RE: ADDENDUM NO. 1 AND ACKNOWLEDGEMENT OF RECEIPT OF ADDENDUM NO. 1

ADDENDUM NUMBER 1

METER REPLACEMENT AND AMR SYSTEM IMPROVEMENTS FOR THE CITY OF DECHERD ARPA NO.: DW-PDC-1 GMC PROJECT NO. CNAS240011

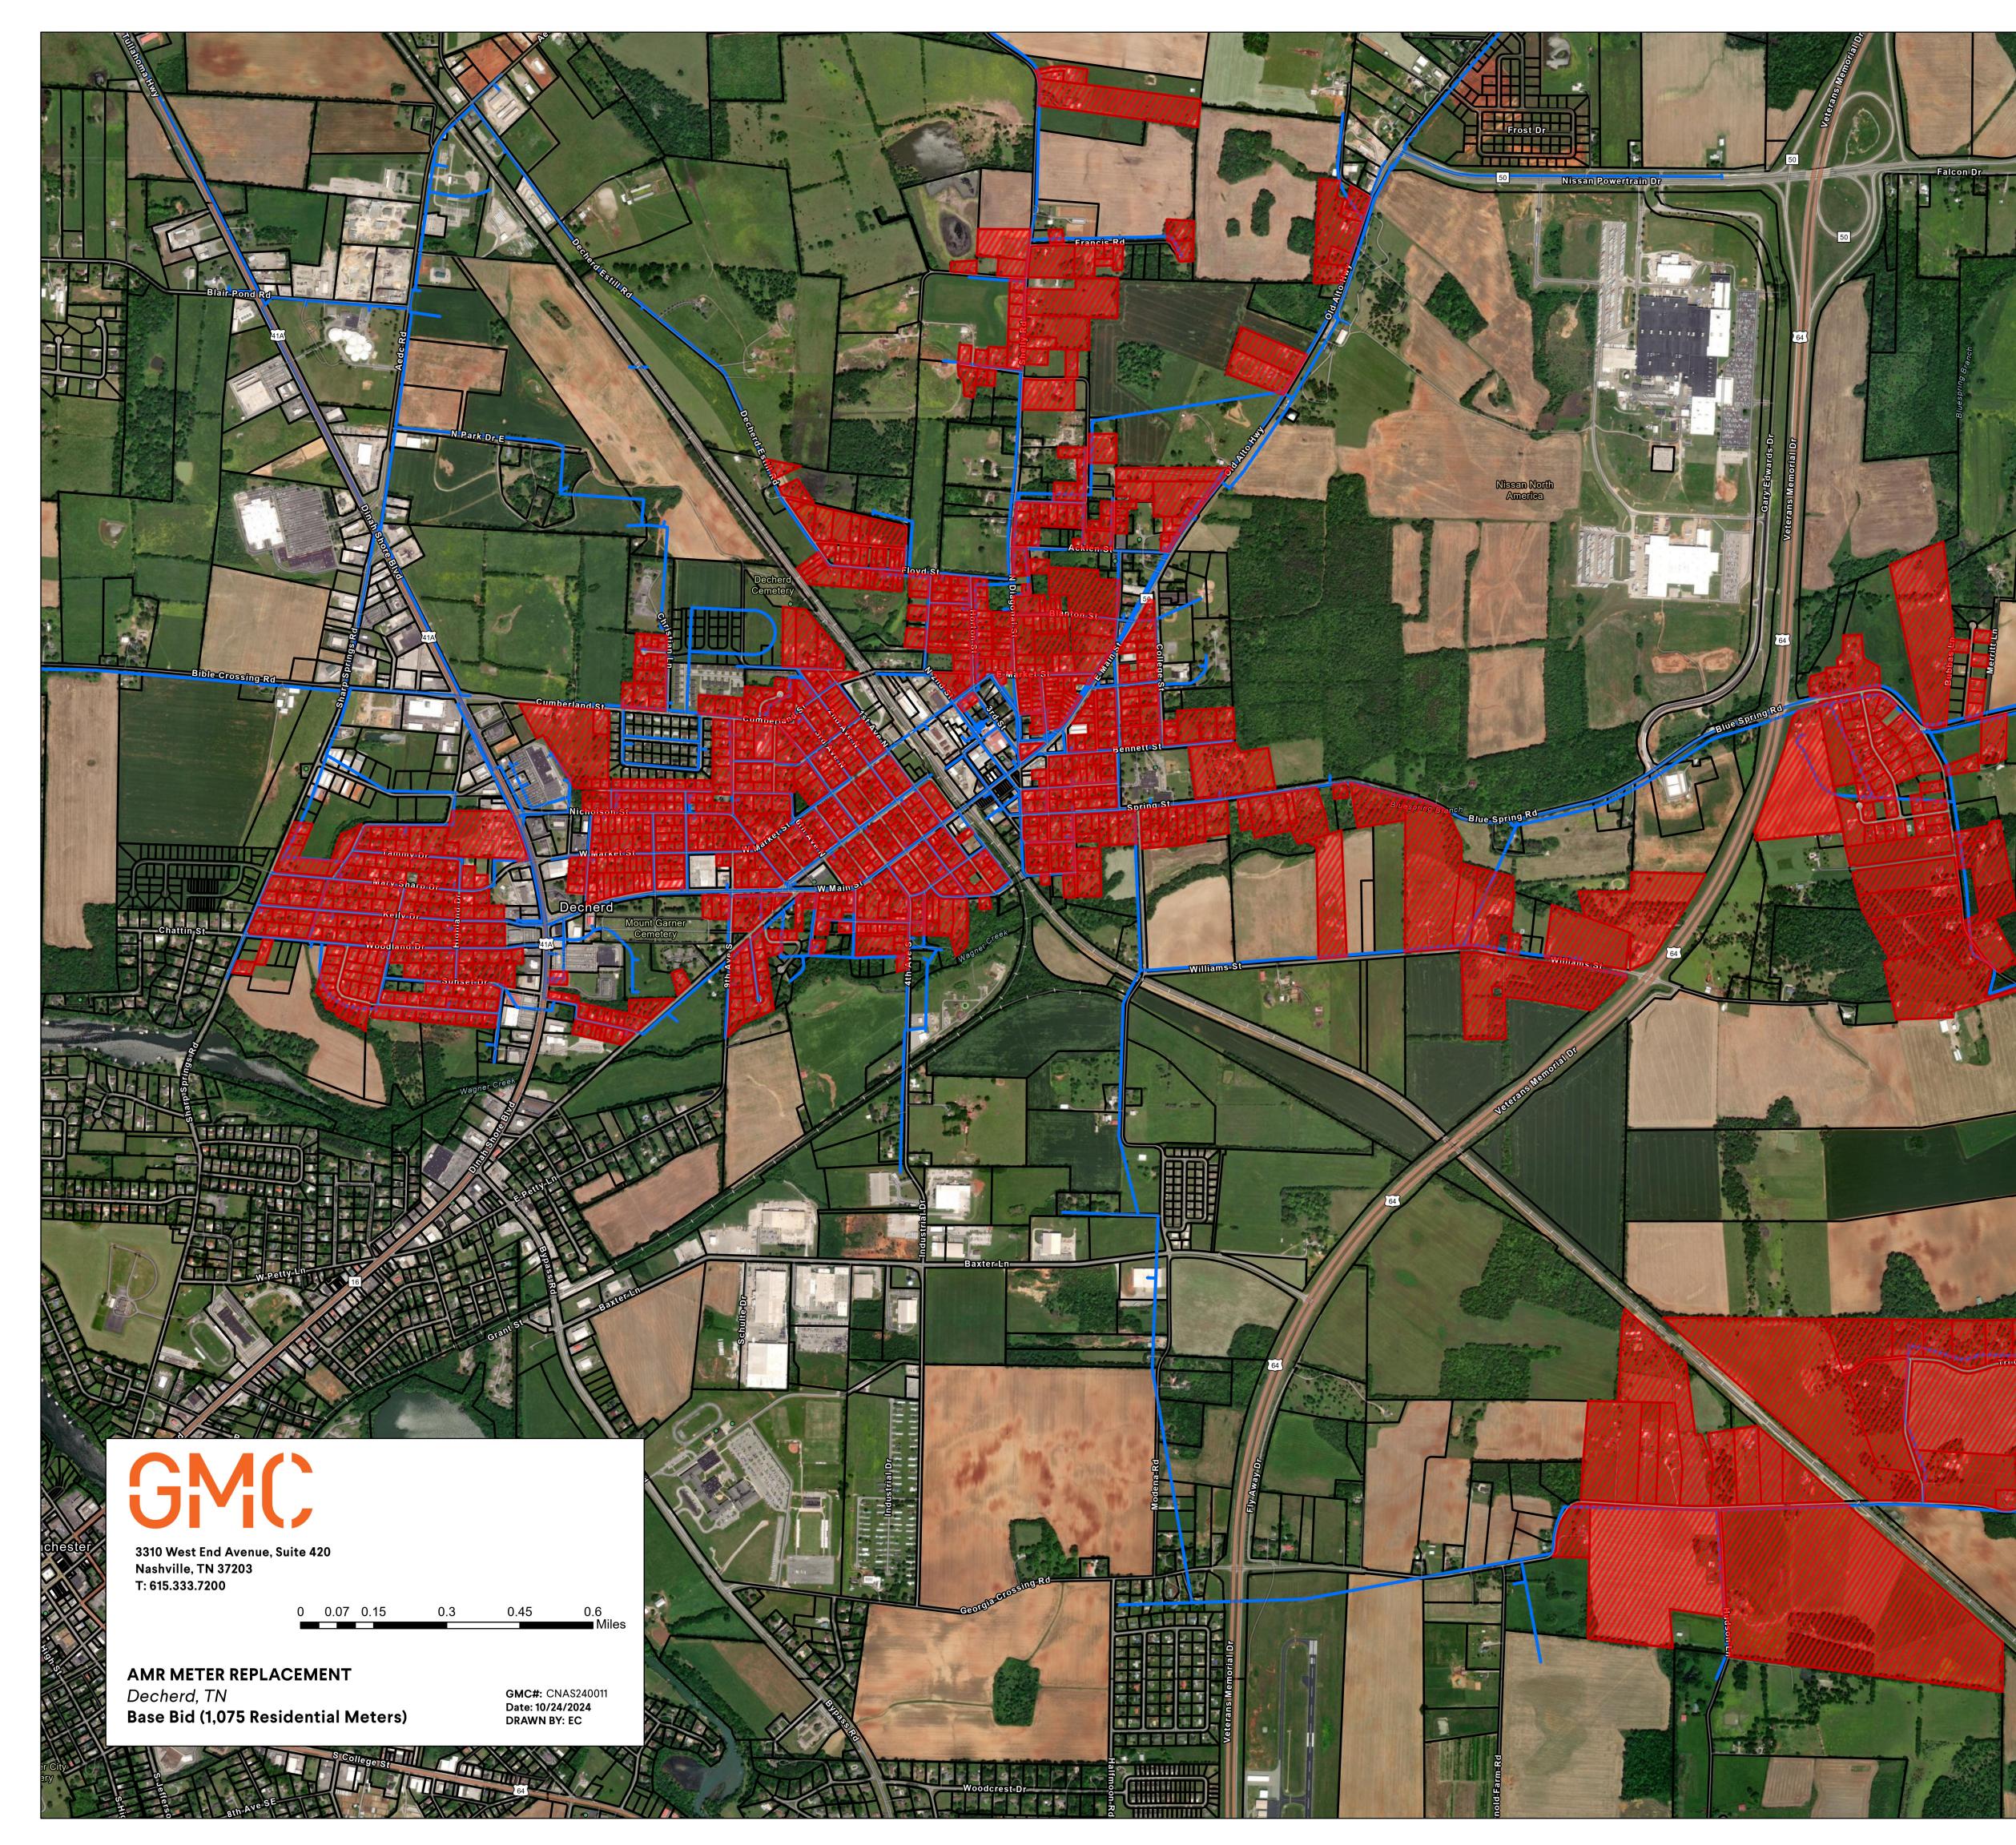
- 2.14 What area of the City is the base bid associated with?
 - A. See attached map of parcels included in base bid, including note regarding how alternates will be handled.

The area outlined in red represents the approximate area for water meter replacement (base bid), subject to change per the City's discretion. Approximately 1,075 parcels are shown, to represent 1,075 meters to be replaced – though it is expected that the meter per parcel ratio is not 1:1 due to some parcels not having a meter connection (i.e. undeveloped) and some parcels having multiple meter connections (e.g. duplex, triplex, etc). If selected, additive alternates will focus on the rural areas surrounding the city.
